Subject: Workplan and Cost Estimate - Additional Investigation, Whitefish Bay Cleaners, 419 West Silver Spring Drive, Glendale, WI

FID: 241246060  
BRRTS: 02-41-550821

Whitefish Bay Cleaners Sample Locations May 2016.jpg

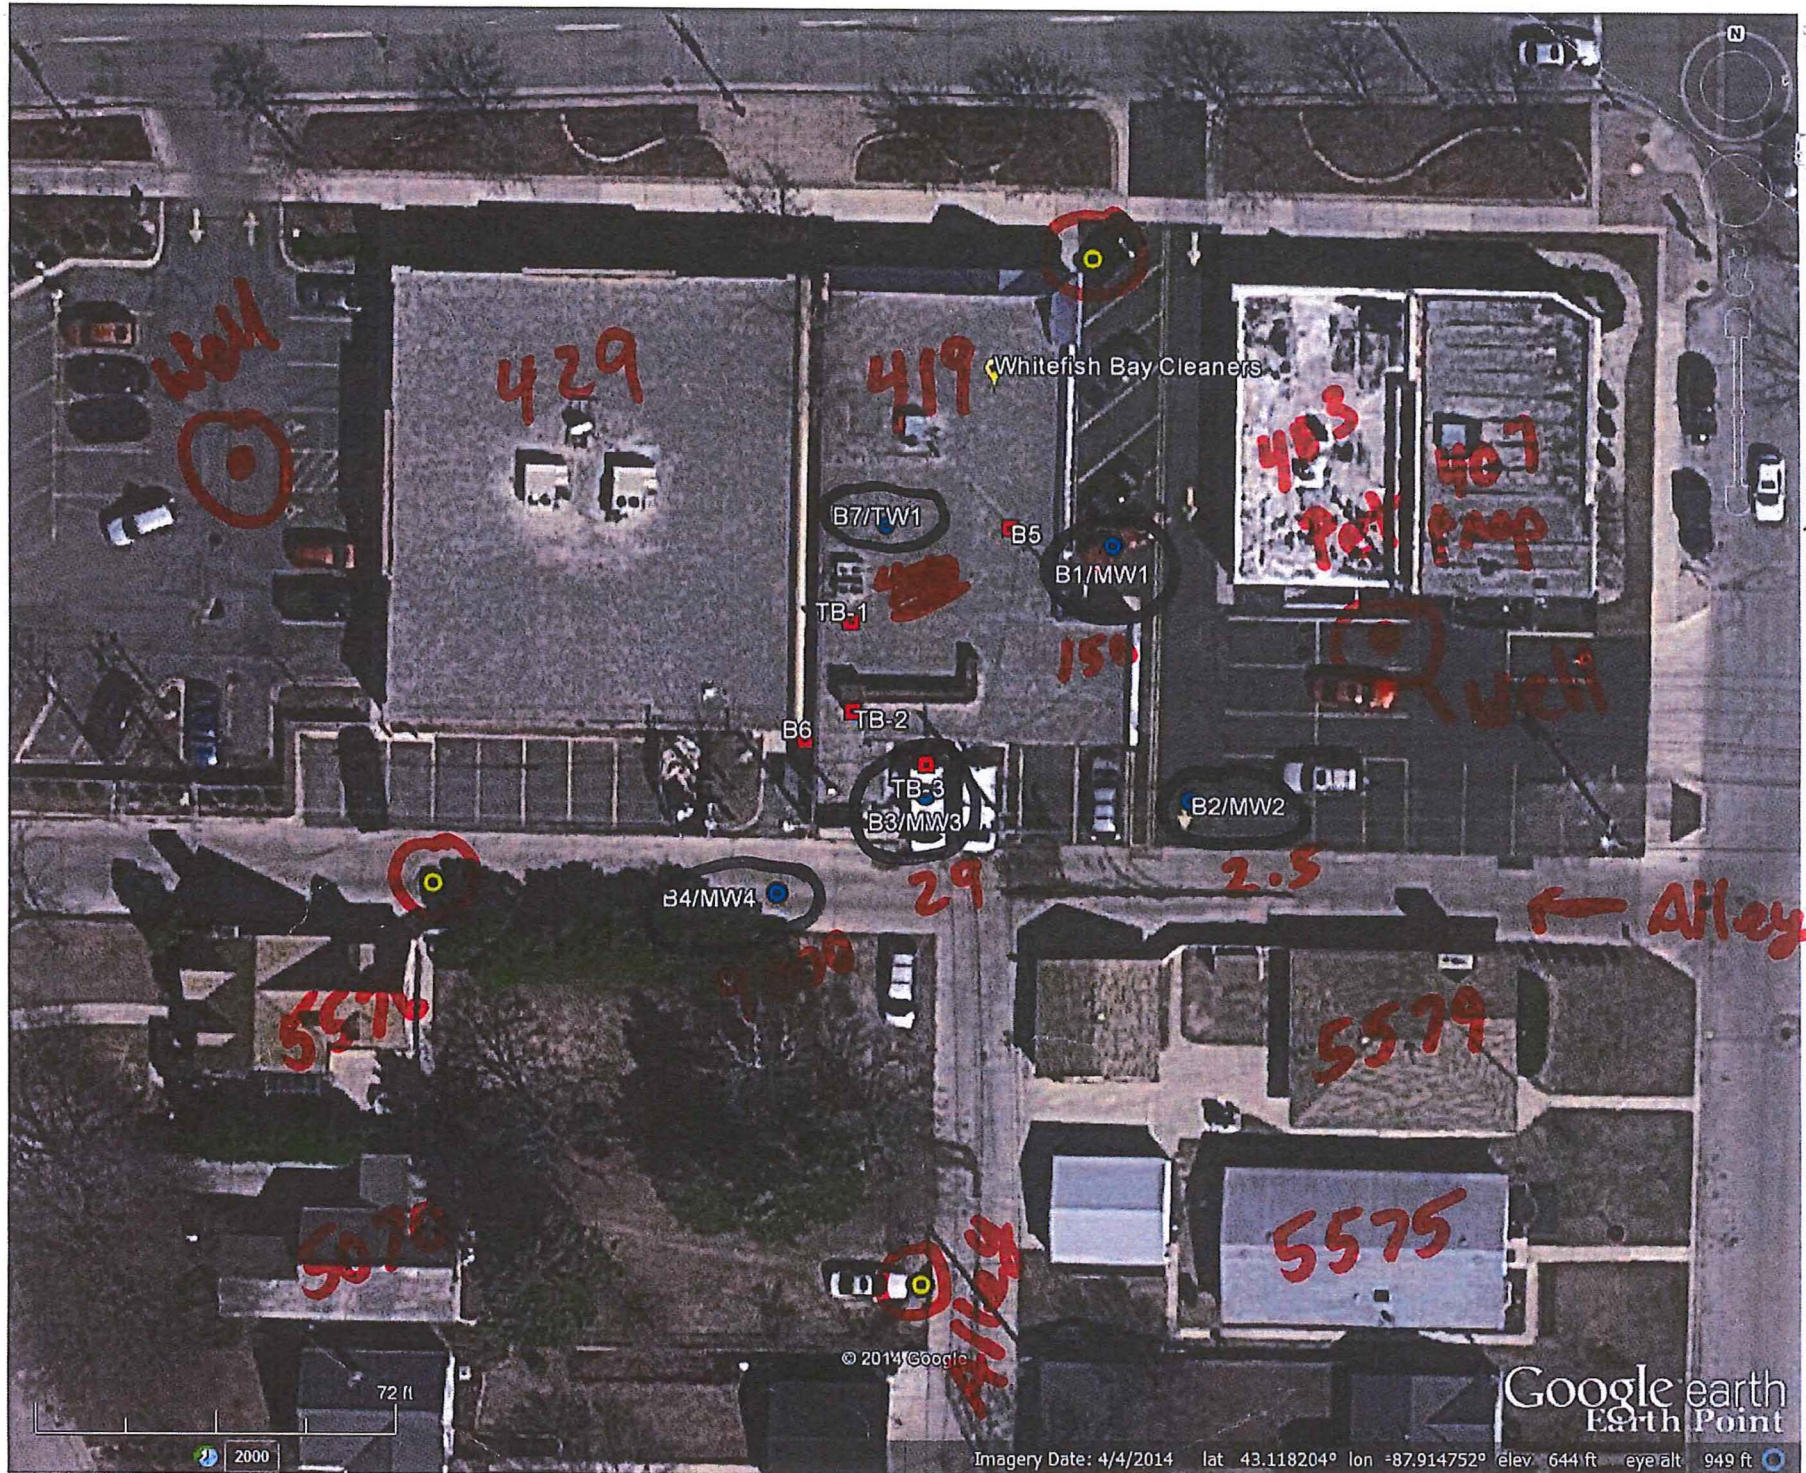
Although the latest site investigation proposal includes additional soil, groundwater, and subslab vapor sampling, the DNR has concerns that there is a higher vapor intrusion risk for the residences located at 5070 and 5576 North Iroquois Avenue and 5575 and 5579 North Mohawk Avenue due to groundwater PCE concentrations in groundwater monitoring wells MW-4 and MW-2, and the close proximity of these residences to these wells.

2. Or, both the residential and commercial sites may be investigated for vapor intrusion at the same time.
3. The NR 141 groundwater monitoring well located approximately 30+ feet south of MW-4, should be relocated to a point in the alleyway approximately 75 to 100-feet south of MW-4 to further define the degree and extent of the groundwater contamination plume (see Figure 1).

- Find out if there's utilities along the east-west and north-south alleyways. If so, do an evaluation for groundwater and vapor migration. Do the utilities intersect the groundwater, sampling along the utilities, etc.
- Subslab in the basement or foundation and indoor air located at buildings #403 and #407, east of site (commercial pet palace)
- Subslab and indoor air for #429 west of site (commercial bedding store)
- Subslab and indoor air for residential houses located at #5576, #5070, #5579, and #5575
- An outdoor air sample if and when subslab and indoor air sampling is completed
- Additional GW monitoring west of #429 in the parking lot
- Additional GW monitoring in the parking lot for #403 and #407
- Your well locations circled in yellow are fine
